INFORMATION REQUEST

Street Address: 14 Murphy Street PORT DOUGLAS
Real Property Description: LOT: 114 TYP: PTD PLN: 2094
Local Government Area: Douglas Shire Council

Application Number: OP2023_5422/1
Approval Sought: Development Permit
Nature of Development Proposed: Operational Works
Description of the Development Proposed: Operational Works (Earthworks associated with construction of a dwelling)

Figure 1: Snippet from Edge Drawing C201

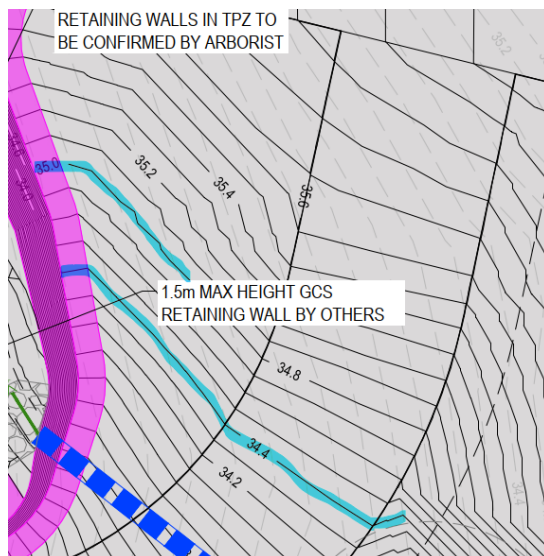
9. Concern is raised regarding labelling of design contours on Edge Drawing C201. The contours are consistent at 0.1m intervals, however, there appears to be conflict between the design levels shown on the south-western side of the allotment. Refer Figure 1 below which shows an elevation difference of 0.4m but the contour labels indicate this level difference is 0.6m.

The Applicant is requested to clarify this inconsistency in the contour labels on Edge Drawing C201. A revised drawing labelling the appropriate design contours is requested.
